## **HAMPTON PARK SUBDIVISION**

APPLICATION NUMBER 9 DATE March 3, 2005

REQUEST Subdivision

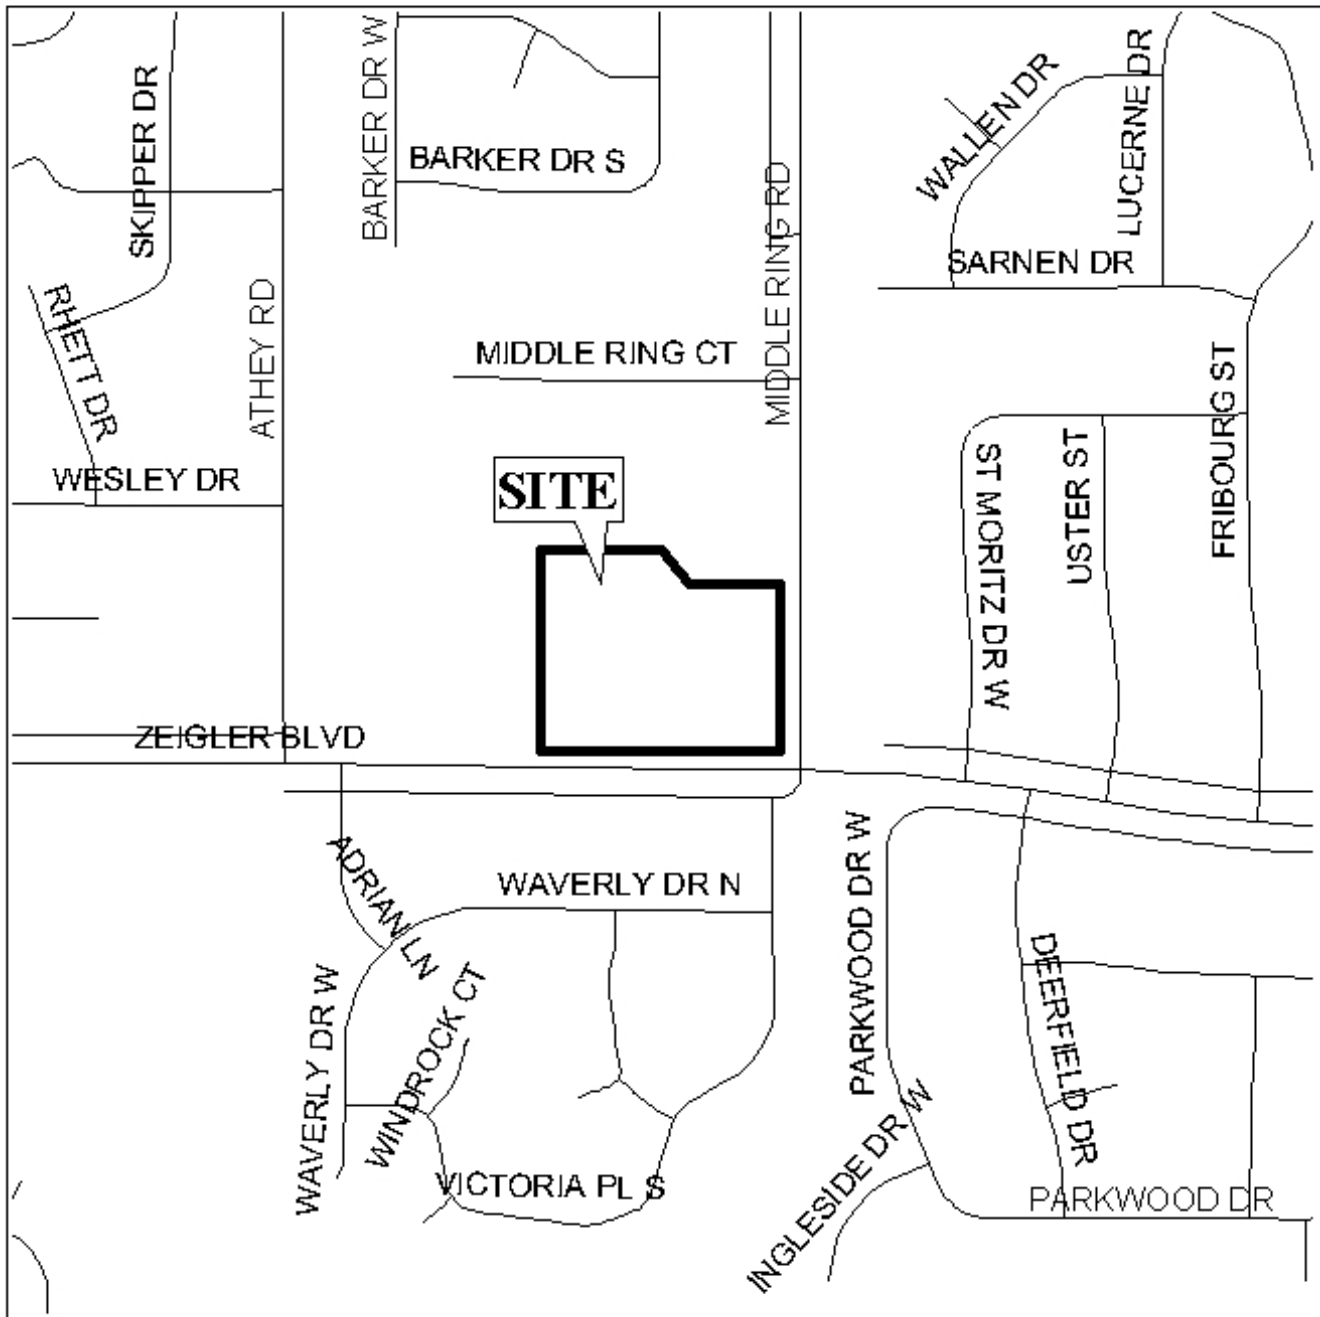
The plat illustrates the proposed 7.1± acre, 19 lot subdivision which is located at the Northwest corner of Zeigler Boulevard and Middle Ring Road and is in Council District 7. The site is served by public water and sanitary sewer.

The site fronts Zeigler Boulevard and Middle Ring Road, both of which are planned major streets, and as such require 100' rights-of-way. It is not clear from the plat whether there is sufficient right-of-way from the centerlines of these roads, since the rights-of-way appear to include service roads as well as the major streets. Therefore, the final plat should show the existing rights-of-way, and dedication of sufficient right-of-way to provide 50 feet from the centerlines of Zeigler Boulevard and Middle Ring Road (excluding service roads). Furthermore, direct access to Zeigler Boulevard and Middle Ring Road should be denied for Lot 1, Lots 11-13, 19, and the common detention area.

The plat meets the minimum standards of the Subdivision Regulations and is recommended for Tentative Approval, subject to the following conditions: 1) the depiction of the existing rights-of-way and centerlines of Zeigler Boulevard and Middle Ring Road; 2) the dedication, as needed, of sufficient right-of-way to provide 50 feet from the centerlines of Zeigler Boulevard and Middle Ring Road (excluding service roads); and 3) the placement of a note on the final plat indicating that direct access to Zeigler Boulevard and Middle Ring Road should be denied to Lot 1, Lots 11-13, 19, and the common detention area.
